ADDENDUM # 2

Project: Monon Community Center Paving Project

Architect's Project No.: W26-0292

DATE: July 23, 2026
TO: Distribute to all Bidders
PROJECT ADDRESS: 1195 Central Park Drive East, Carmel, Indiana 46032

SHEET NO.
C300

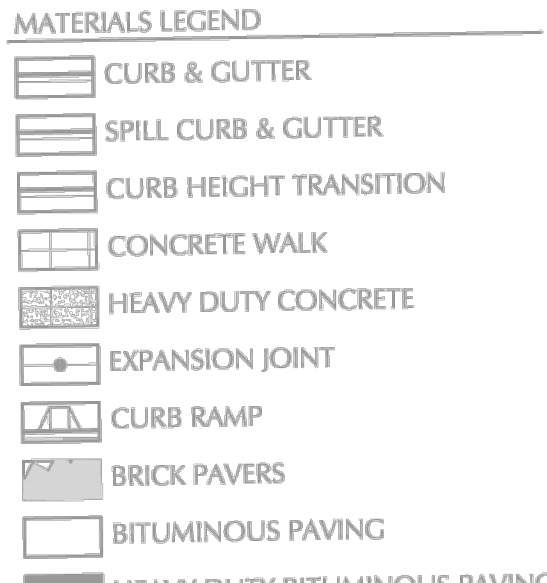
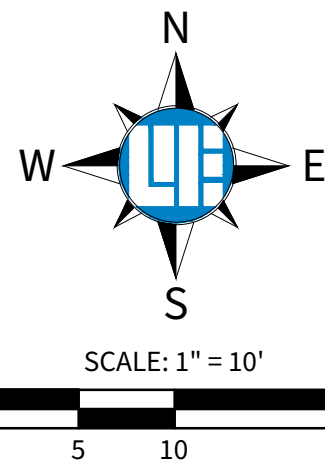
Question: Sheet C300 appears to be missing one signage and marking note S1 for a planter/limestone rock. Can you confirm this unmarked item needs to be new as well? Response: No. The bollard shown in the original design drawings has since been replaced with a structural column.

<u>ITEM</u>	<u>DESCRIPTION</u>
ADD #2-D1	C300-C800. Revised sheets are attached.

SHEET NO.
C30

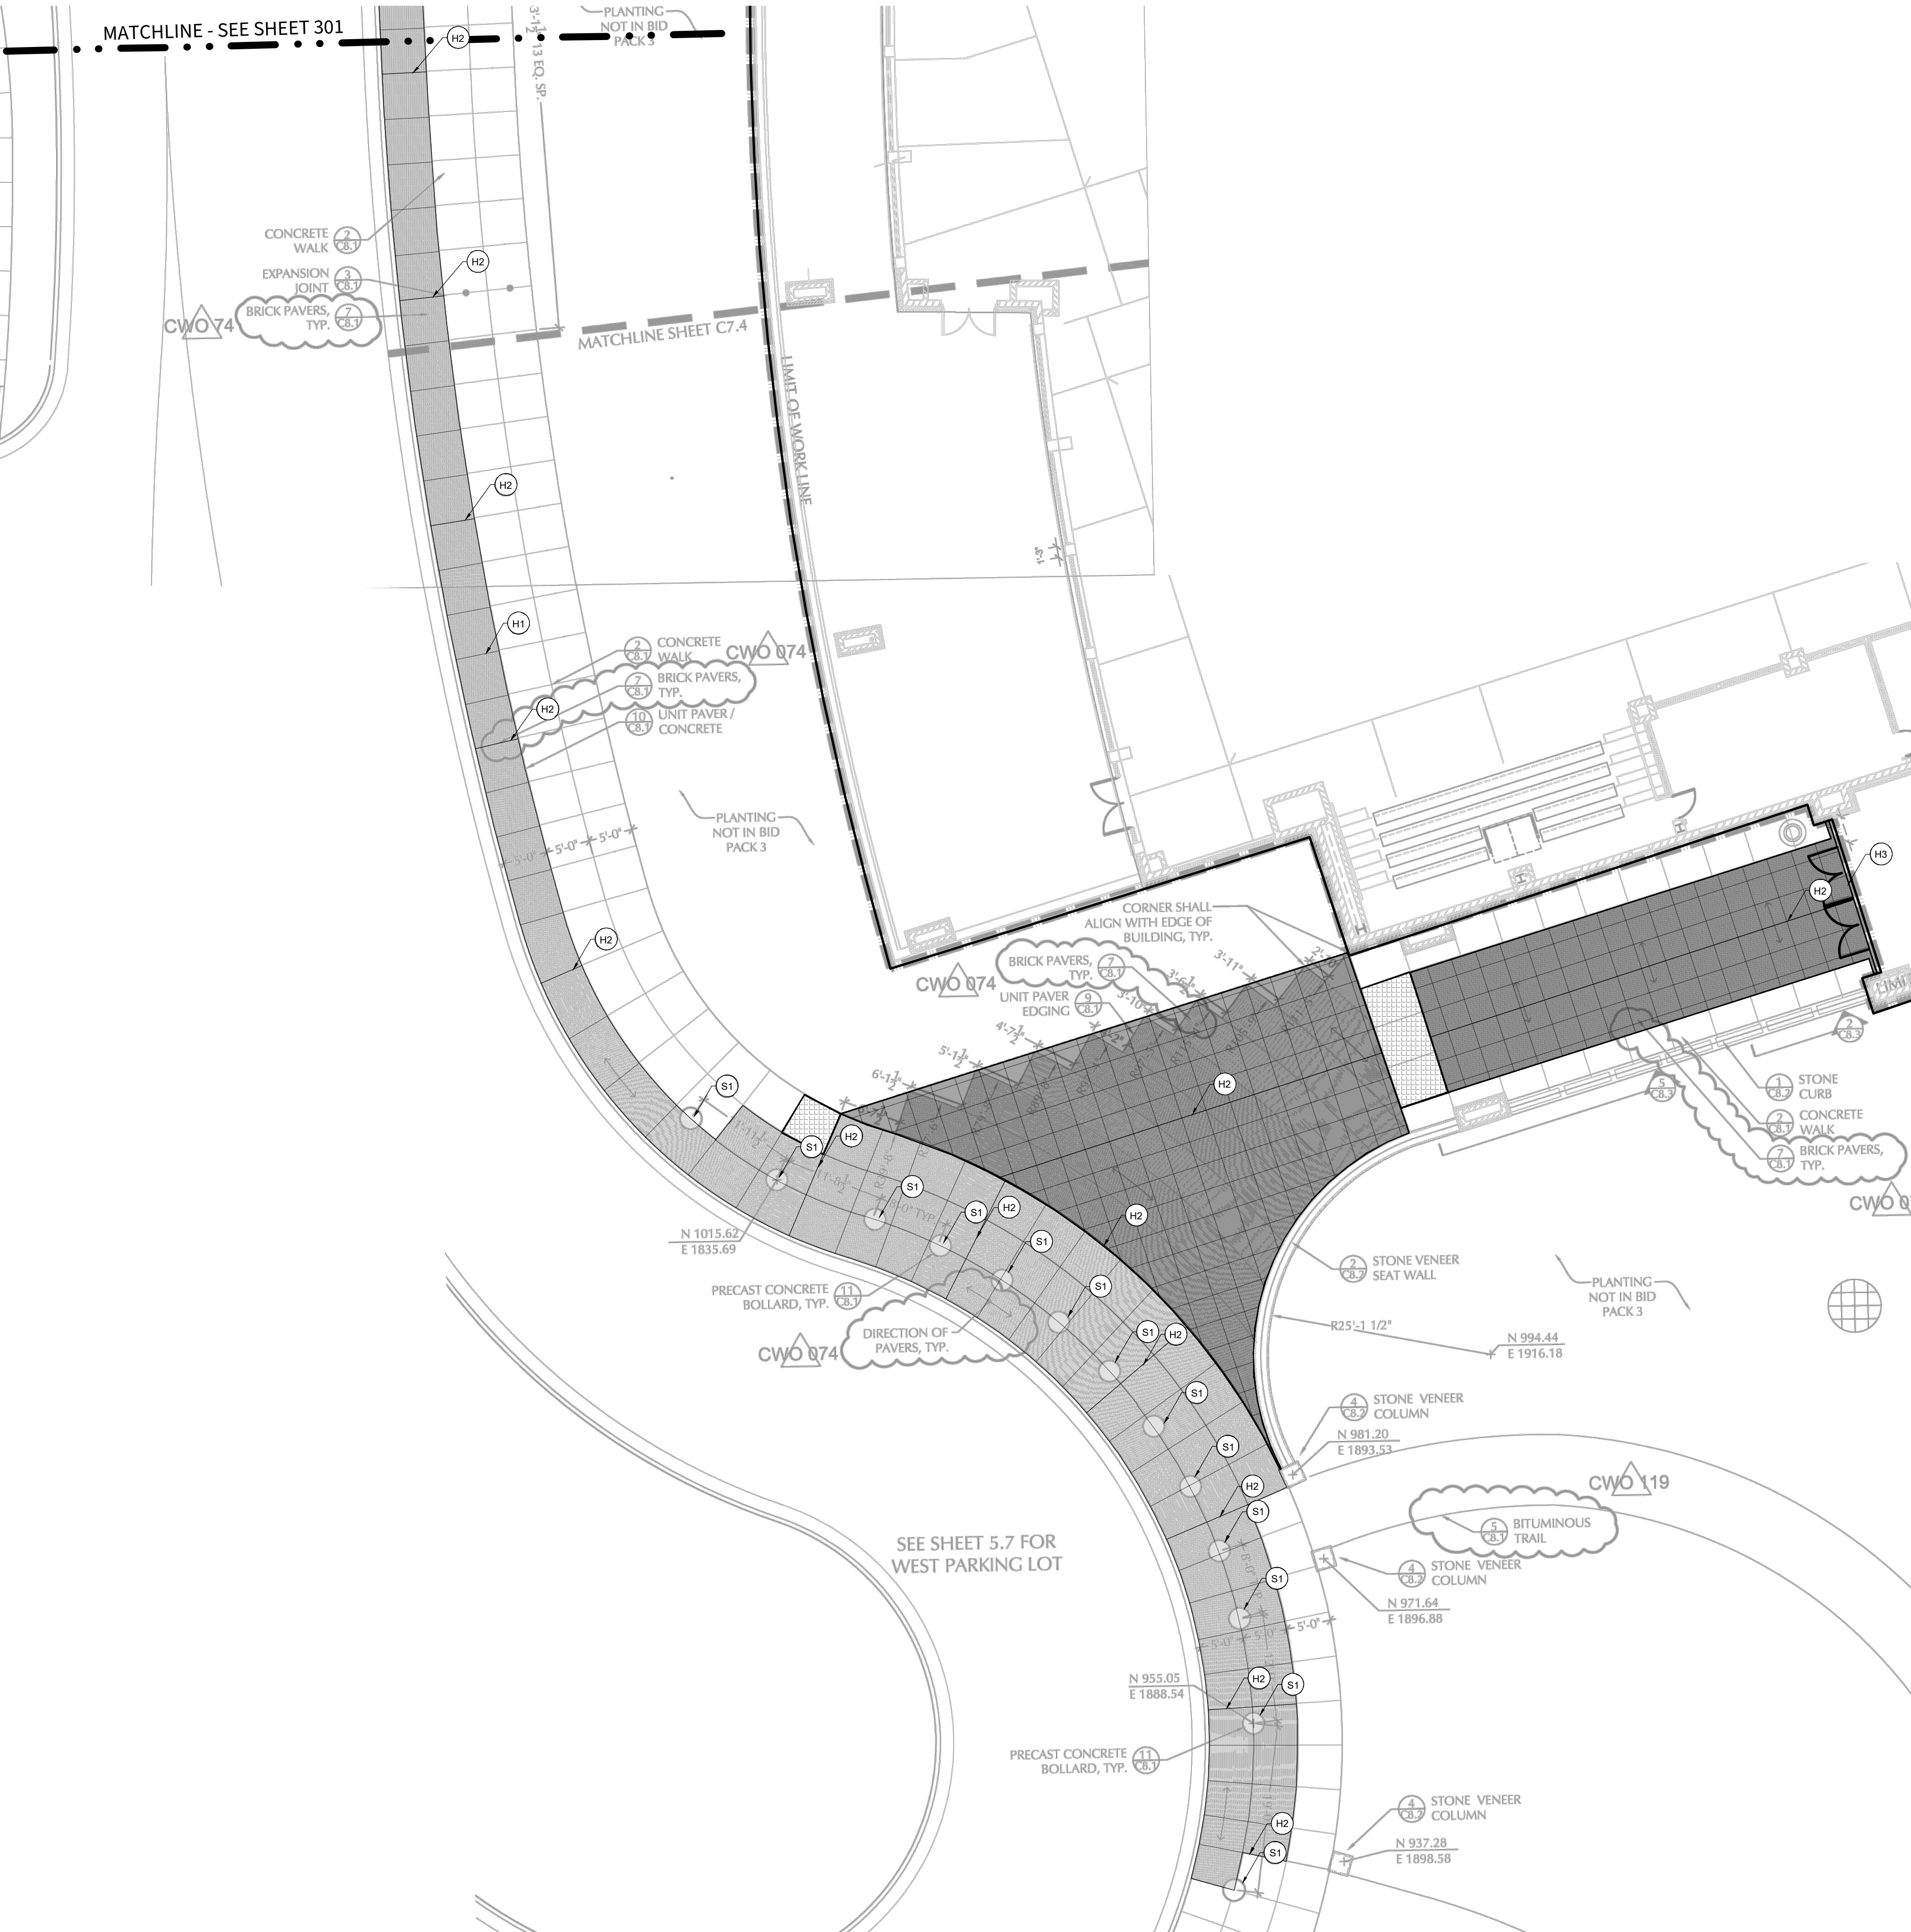
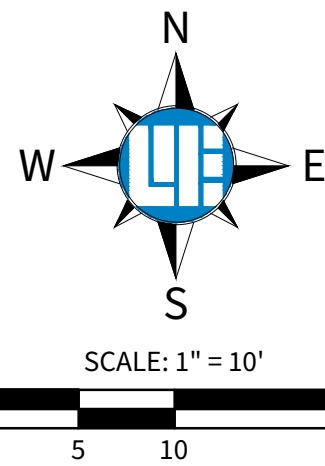
Question: Sheet C301 - Signage and Markings note S2 states concrete to be doweled into abutting concrete minimum of 1 Dowel per square. When referring to Detail 9 on Sheet C800, it states dowels are to be every 24" O.C. Can you please confirm which is correct? Response: Contractor should aim for 24" spacing, and use professional discretion when joints are in conflict. Contractor should, at a minimum, include one dowel into each adjacent concrete curb or panel.

Question: The current match lines on the drawings do not seem to align; can you provide match lines from sheet to sheet? Response: Sheets C300-C304 have been adjusted to show matchlines.
